SERVICE BULLETIN

NUMBER: 23-025-05

Deck Lid Closing Effort

2003 - 2005 (ZB) Viper SRT10

Fig. 1 TRUNK WEATHERSTRIP MOUNTING FLANGE REVISION

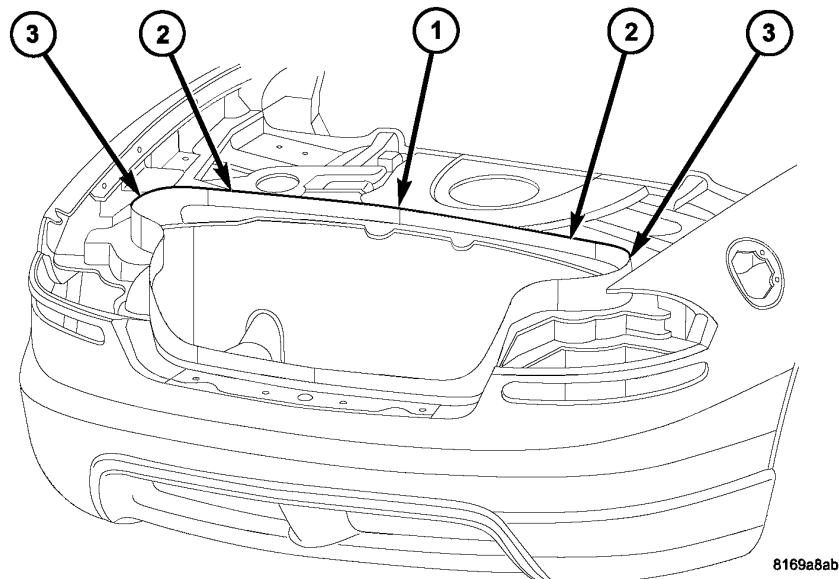
1. Remove trunk weatherstrip along the forward mounting flange ([Fig. 1](#)).
2. Mark the inboard edge of the forward trunk weatherstrip mounting flange with masking tape to outline the material to be removed, 3mm (0.118 in.) at the center of the flange and reduce to zero toward the outboard ends of the flange as illustrated, ([Fig. 1](#)).

1 - REMOVE 3mm OF FLANGE HEIGHT

2 - REMOVE 2mm OF FLANGE HEIGHT

3 - REMOVE 0mm OF FLANGE HEIGHT

3. Reduce the forward trunk weatherstrip mounting flange height by filing/grinding away material along the edge of the tape placed in step 2.
4. Remove the masking tape.
5. Clean (vacuum) the area of all debris.
6. Install trunk weatherstrip.
7. Close the deck lid and check the effort required.
8. Adjust deck lid latch striker down as necessary, 2mm (0.079 in.) maximum. Torque the latch striker bolts to 12Nm (105 in. lbs.).
